August 18, 2021

Marlon Pangilinan, emailed
Senior Planner, City of San Diego
Planning Department

Regarding: Clairemont Community Plan Update, Community Discussion Draft May 2021 Draft

Unrecognized Open Space

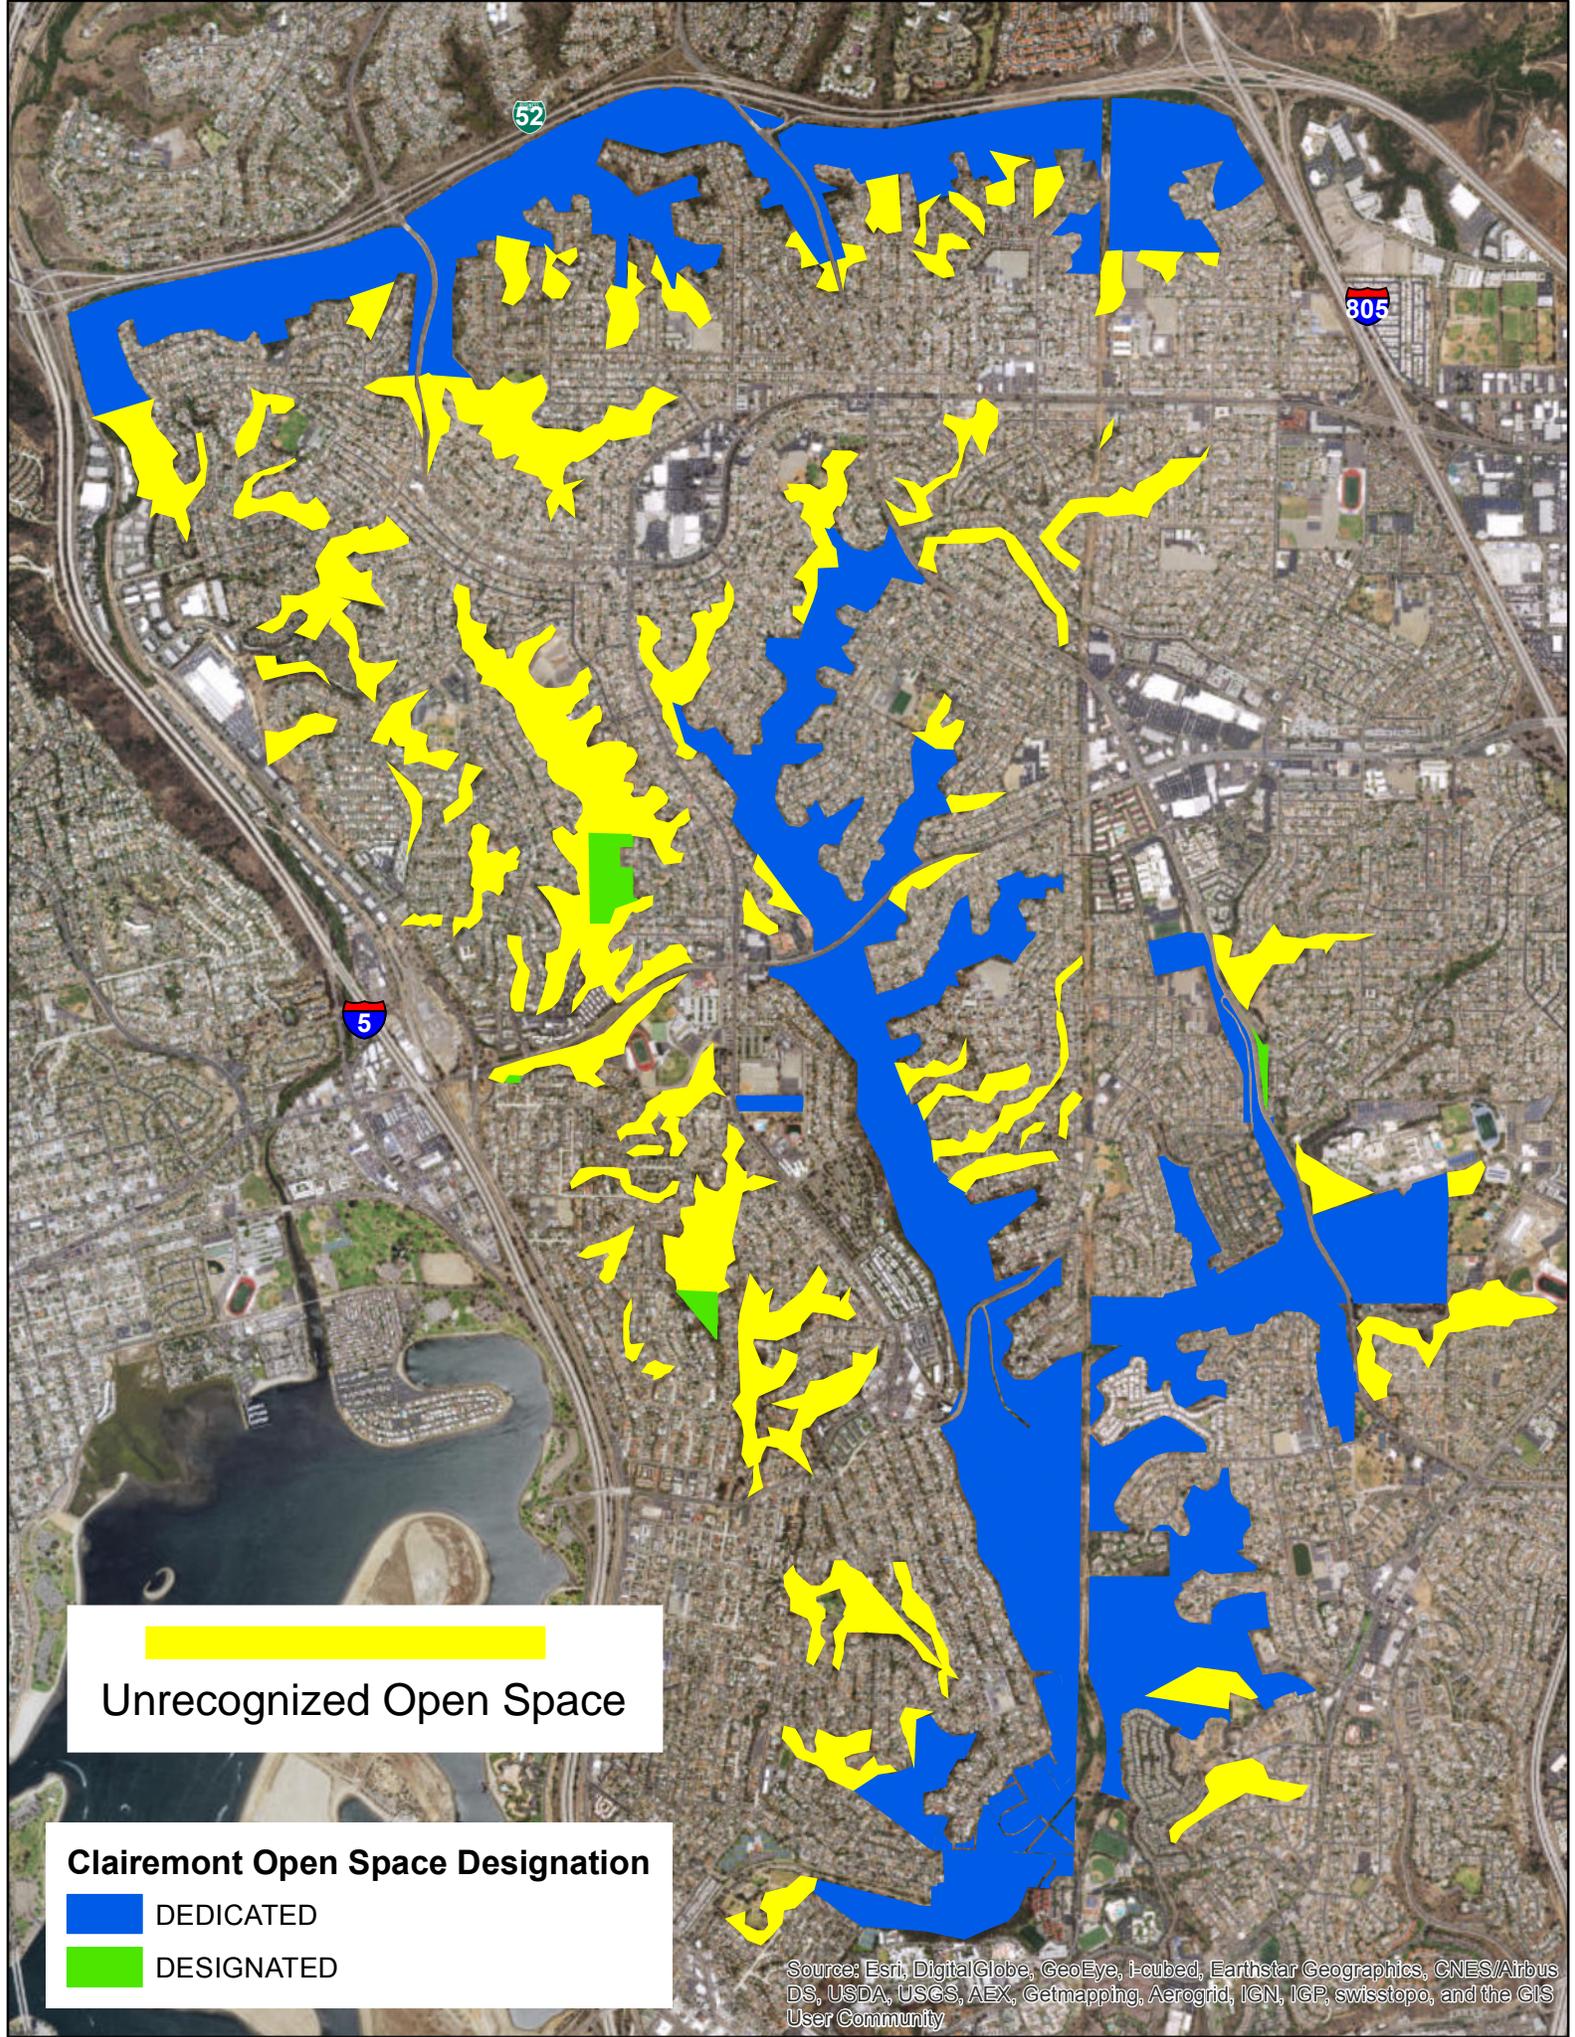
- iv. Please find the attached maps obtained from City of San Diego illustrating open space in Clairemont. In the second map I have illustrated in yellow the unrecognized, and one would assume partly unprotected, open spaces in our community. How can all of these open spaces that are integral to the health and wellbeing of our community be protected?

Beach Express Skyway

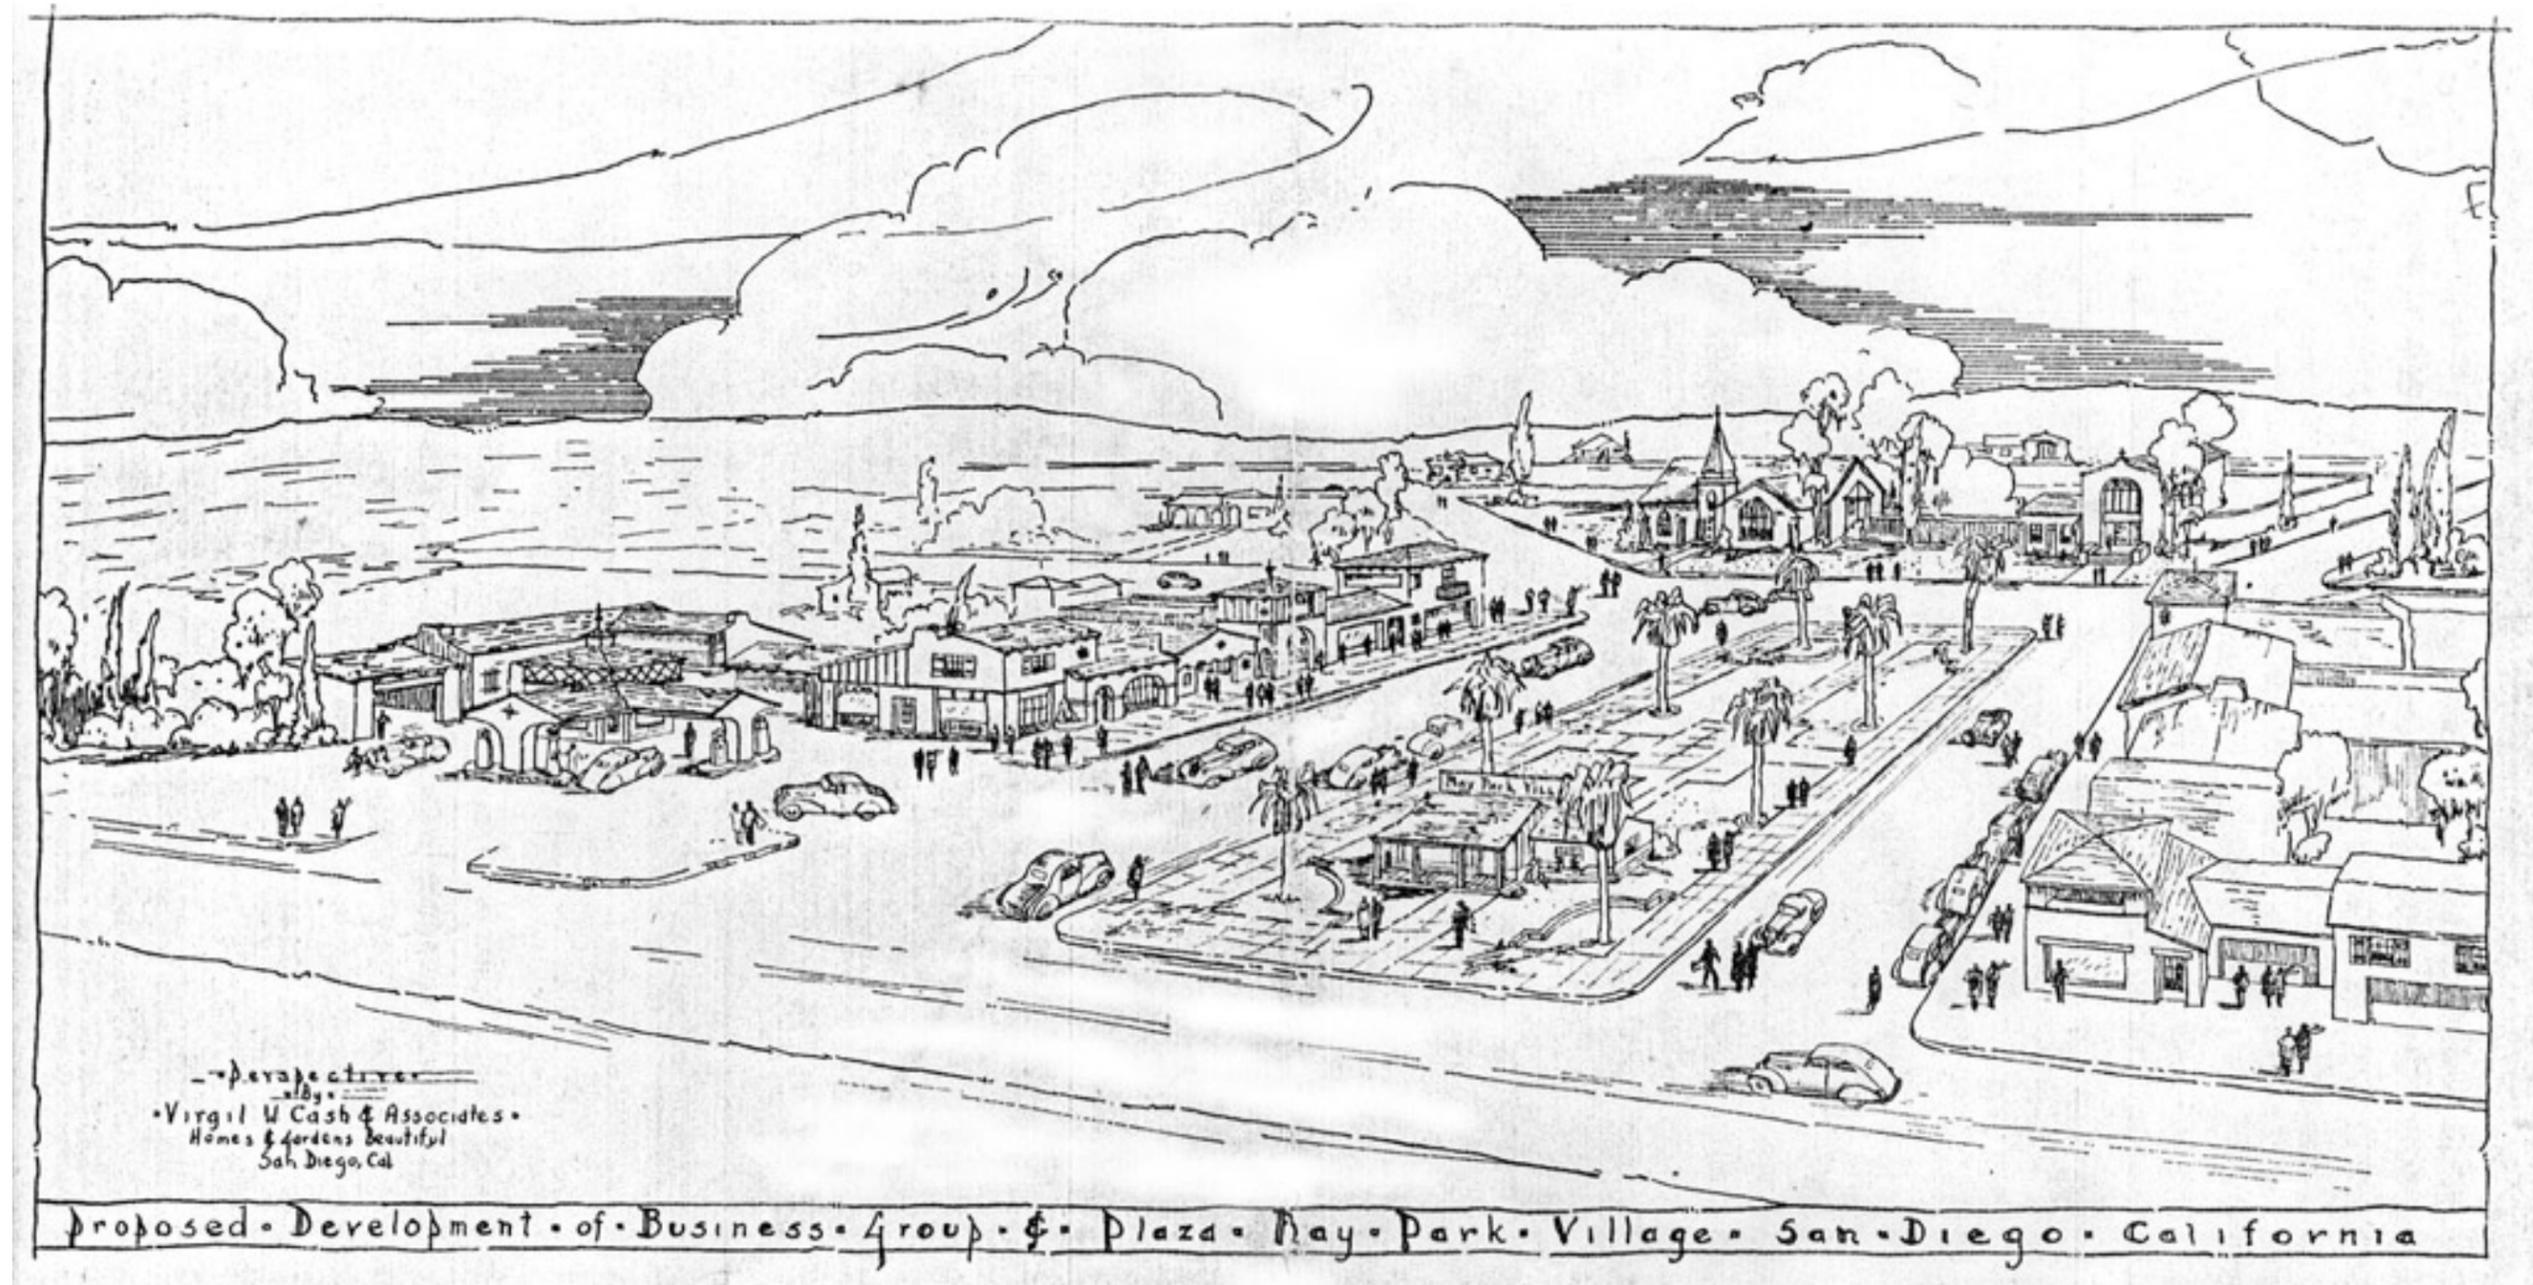
- g. It is my opinion that a pedestrian/bicycle bridge should be included at the Balboa Station to link the high-density housing planned along West Mission Bay Drive. The ideal location of an aerial tram would be to link the Tecolote Station with Mission Bay, Sea World and Mission Beach at Bonita Cove. This goes outside of the study area but please see the attached illustration for the “Beach Aerial Express”.

Bay Park Town Center Park

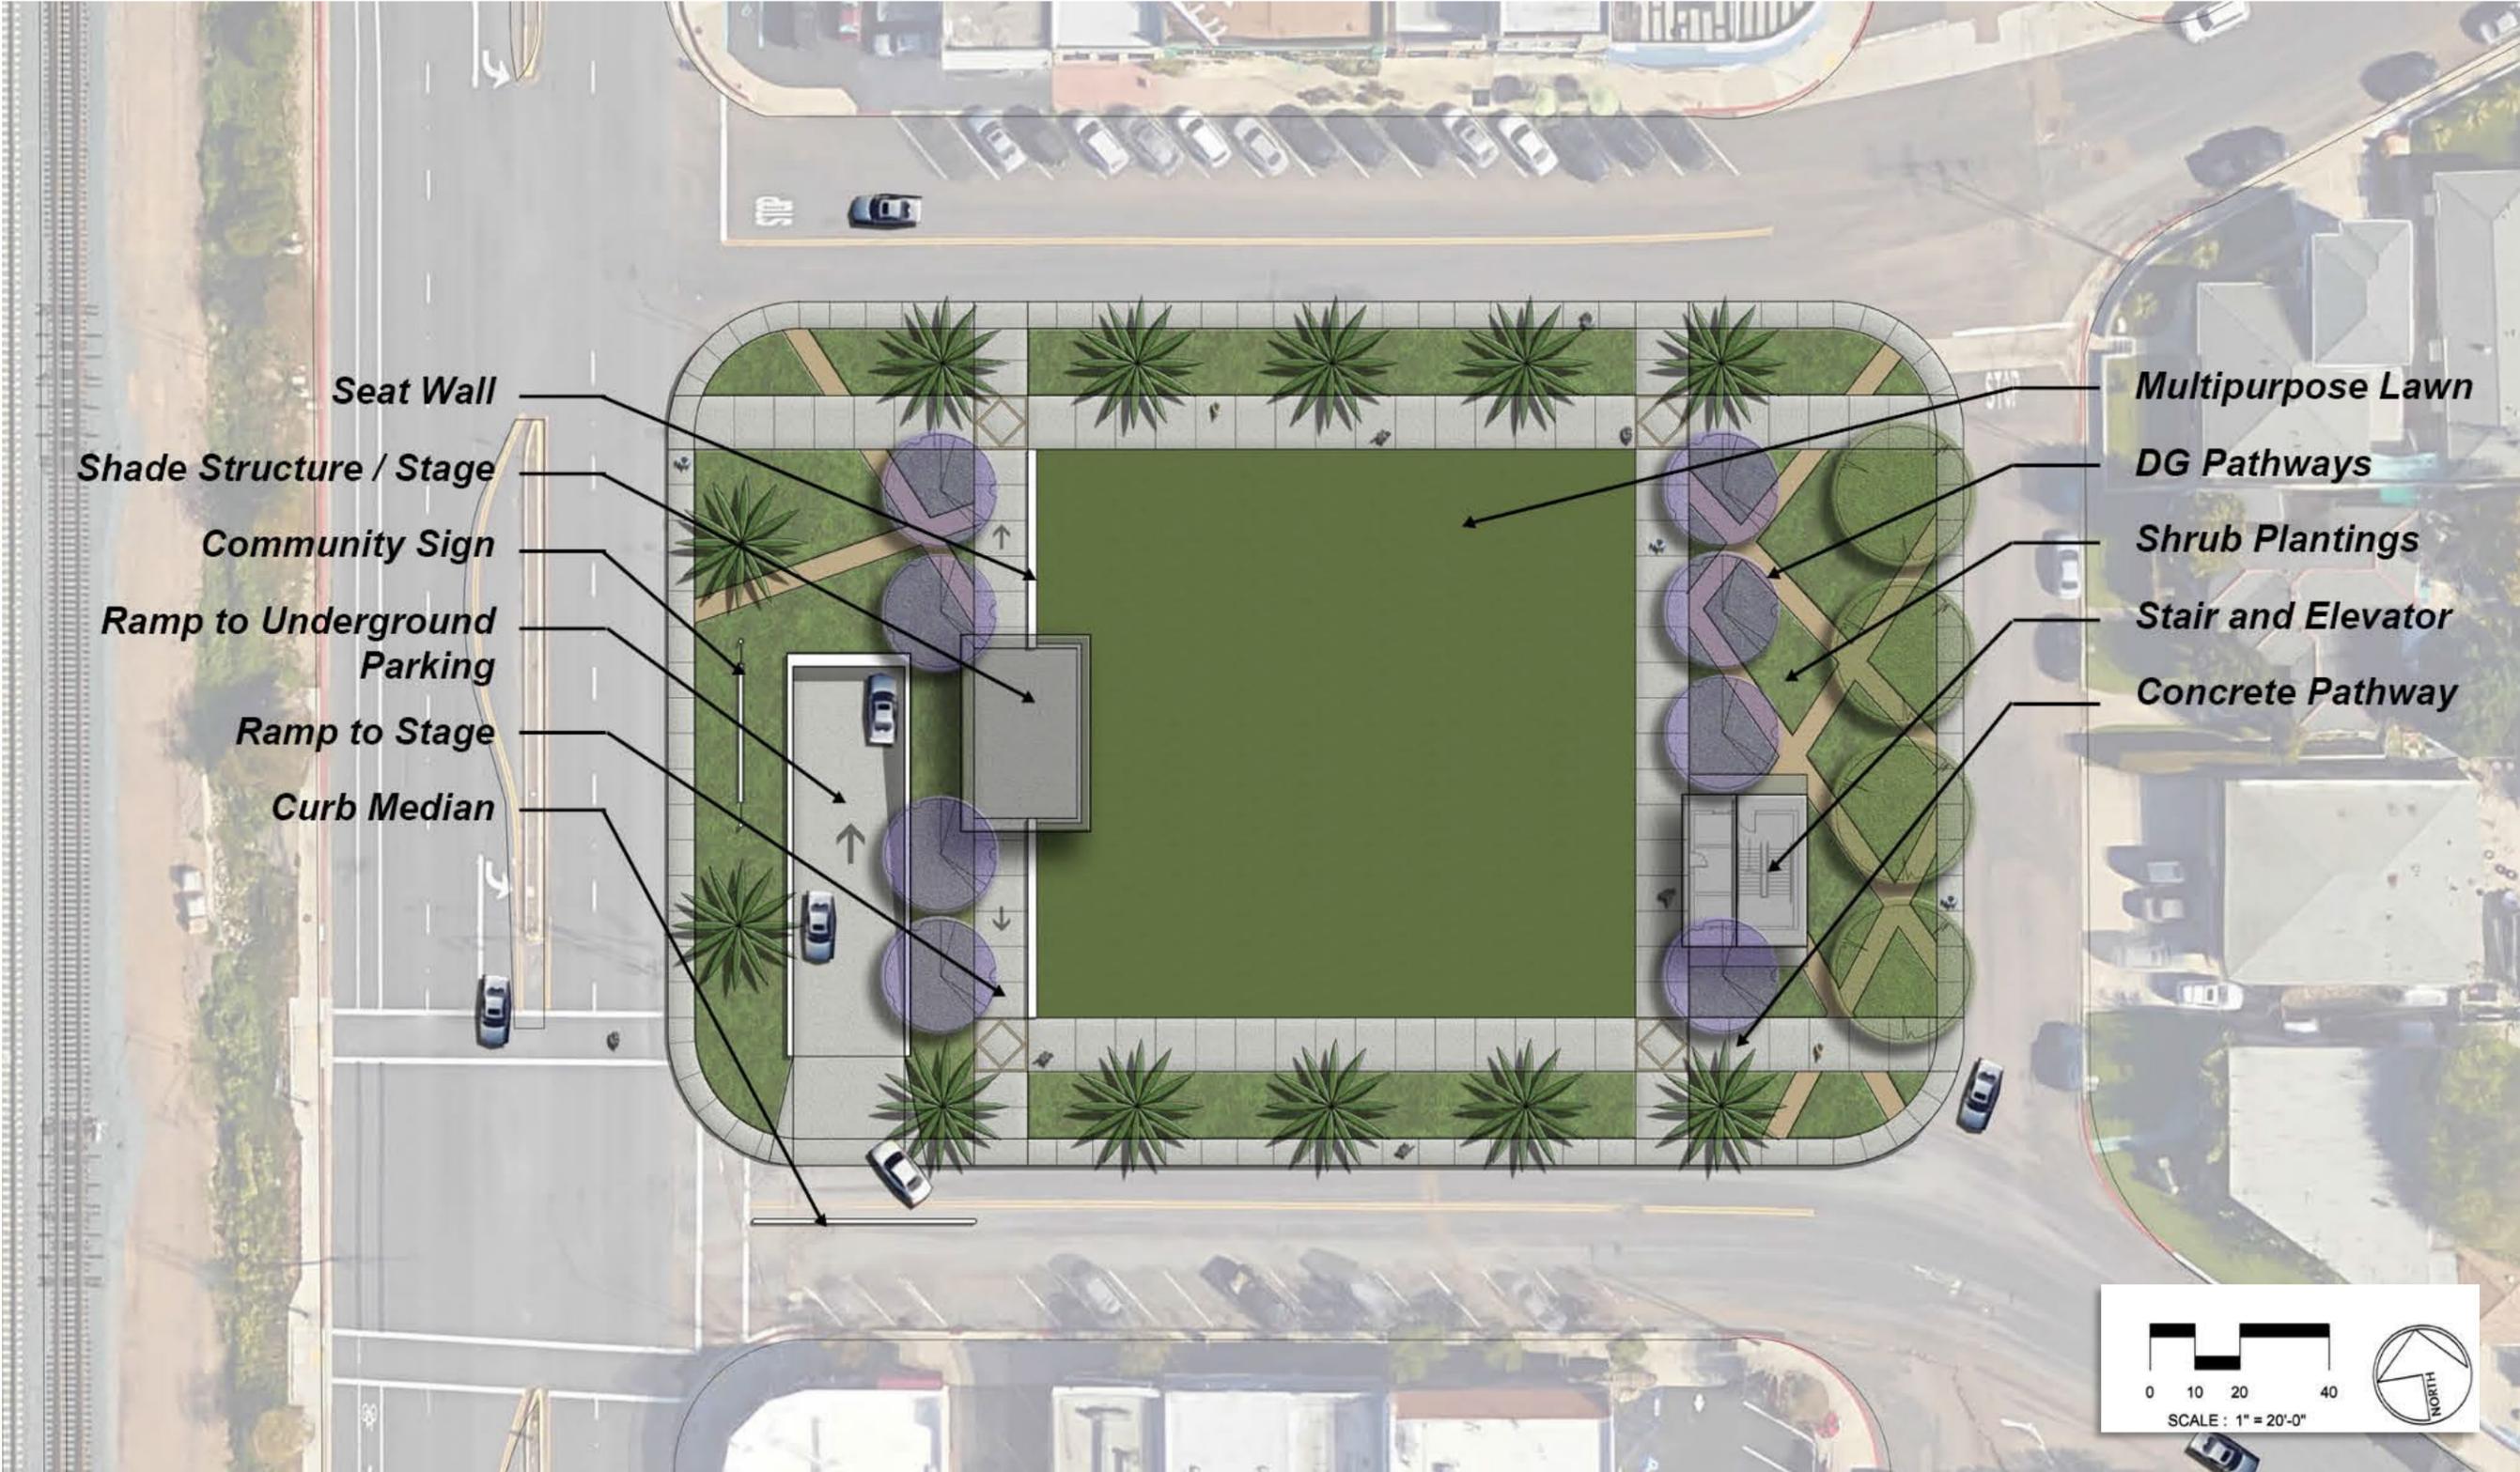
Park Village subdivision. It is disappointing to see this area only shown as a “node” when it is the heart of the Bay Park community. As a long-term vision, I have suggested that some or all of these parcels could become park land in the future returning the Bay Park Village to its original glory. In the Parks Master Plan, the city has set the goal of adding 100 acres of parkland in the next 10 years. Once communities of concern have been made whole from a park’s perspective, wouldn’t it be possible for one or more of the parcels in this area to be purchased and returned to park land?
